Presentation from Greenpeace

**Ontario Power Generation Inc.,
Pickering Nuclear Generating Station**

Request for a ten-year renewal of its Nuclear Power Reactor Operating Licence for the Pickering Nuclear Generating Station

Preparing for Pickering's closure

LRF Whole-Site Aggregation

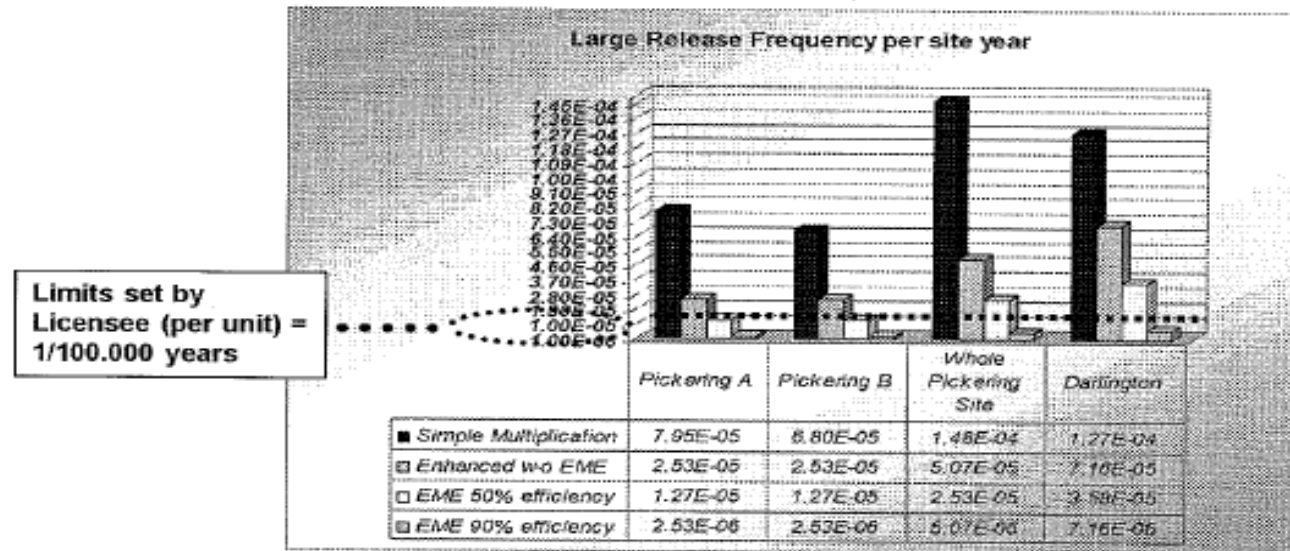
- For Pickering A, multiplication factor for unit LRF is 1.27 instead of 2
- For Pickering B, multiplication factor for unit LRF is 1.3 instead of 4
- For Darlington, multiplication factor for unit LRF is 2.25 instead of 4

Offsite radiation exposure risk has been underestimated
